FDI	ENGINEERING CHANGE ORDER		ECO NO: 10-066
			Page 1 of 5
TITLE	DWG NO.	CURRENT REV	NEW REV
uEZ GUI 4p3	uEZ GUI 4.3 Sharp	2	3

Update the uEZGUI 4.3 to the same enhanced feature set of the uEZGUI 7.0;

DESCRIPTION OF CHANGE:

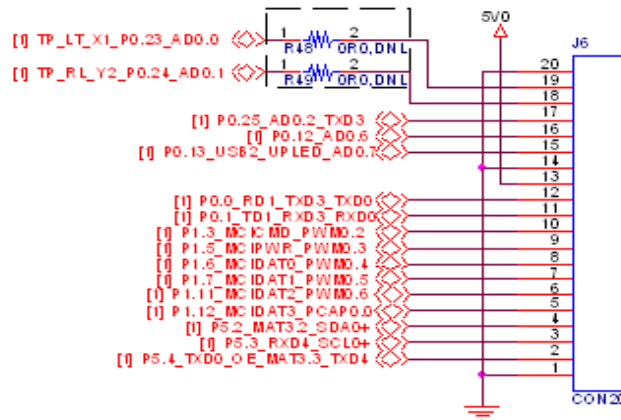
1. Add PN details for LPC1788 as alternative for U11 (LPC1788FBD208)
2. Add/change the following connections to U11;
(net name changes should be applied to the complete schematic)

- a. Add P0.0_RD1_TXD3_TXD0 to pin 94
 - b. Add P0.1_TD1_RXD3_RXD0 to pin 96
 - c. Add P0.12_AD0.6 to pin 41
 - d. Change net name on pin 45 to P0.13_USB2_UPLD_AD0.7

- e. Change net name on pin 116 to P0.22_MCIDAT0_RTS1
 - f. Change net name on pin 18 to TP_LT_X1_P0.23_AD0.0
 - g. Change net name on pin 16 to TP_RL_Y2_P0.24_AD0.1

- h. Change net name on pin 14 to P0.25_AD0.2_TXD3
 - i. Move TP_LL_X2 from pin 91 to pin 67
 - j. Move TP_RT_Y1 from pin 99 to pin 66
 - k. Move LOCAL_SDA from pin 50 to pin 91

- l. Move LOCAL_SCL from pin 48 to pin 99
 - m. Change net name on pin 61 to P0.29_USB1_DP_EINT0
 - n. Change net name on pin 62 to P0.30_USB1_DM_EINT1
 - o. Add P1.3_MCICMD_PWM0.2 to pin 177

- p. Move HEARTBEAT from pin 156 to pin 147
 - q. Add P1.5_MCIPWR_PWM0.3 to pin 156
 - r. Add P1.6_MCIDAT0_PWM0.4 to pin 171

SECONDARY EXPANSION CONNECTOR

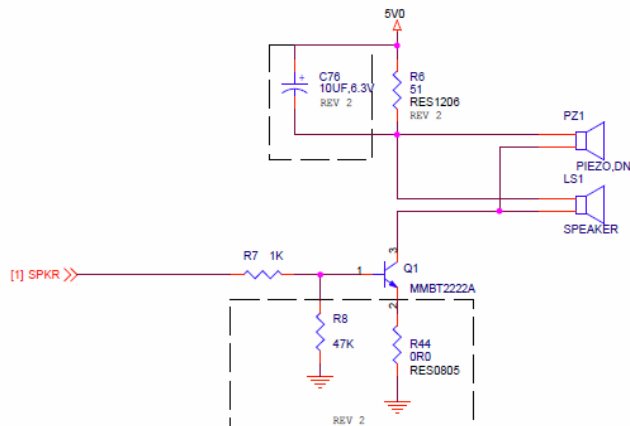
3. Change U4 to LM75BD (see uEZGUI 7.0 U6)
 4. Load U1(74LVC1G08GW) (change from DNL)
 5. Change R1 to DNL
 6. Add 2nd expansions connector from uEZGUI 7.0 Seiko design as shown below;

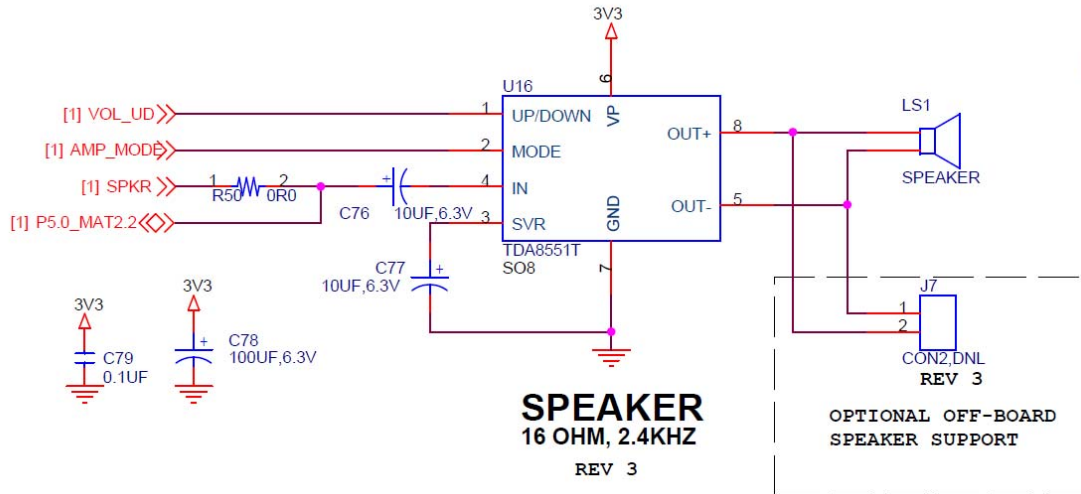
- 8. Add TDA8551T Speaker Driver circuit as shown below;
(add U16, R50, C77, C78, C79 – retained C76 & LS1)

9. Add optional 2pin SMT header, J7, Digikey PN: H2219-ND to the speaker signals U16 pin 8 & 5 (dnl)

Battery Backup Changes

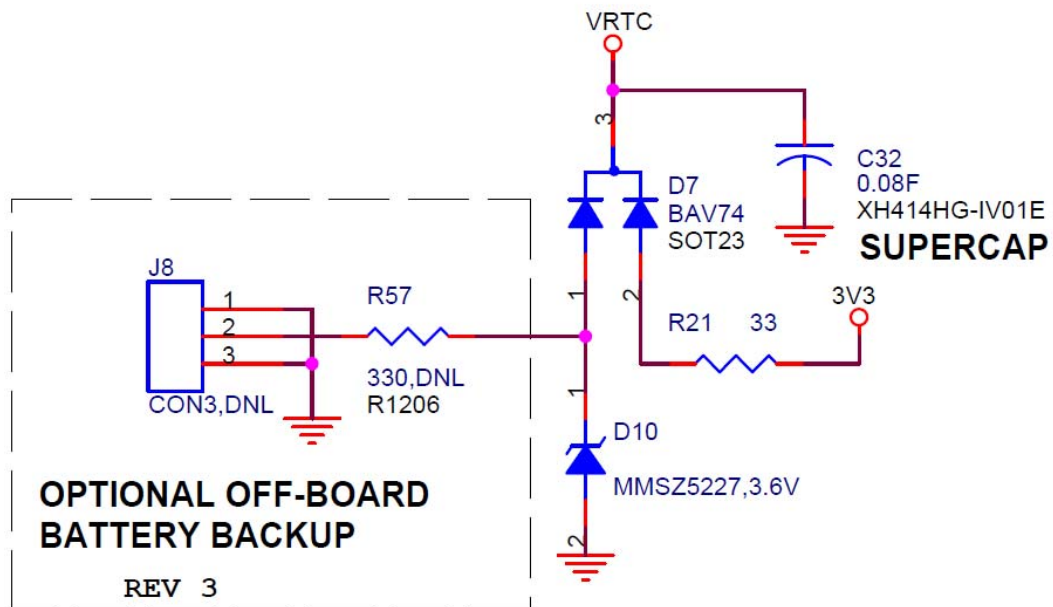
10. Add 330ohm 1/4W series resistor, R57, Digikey PN: P330FTR-ND
11. Add 3.6V Zener Diode, D10, Digikey PN: MMSZ5227BS-FDICT-ND
12. Change diode D7 from BAS416 to BAV74, Digikey PN: 568-1623-2-ND
13. Add optional 3-pin SMT header J8, Digikey PN: H2220-ND to the VBat signals as shown below (dnl):
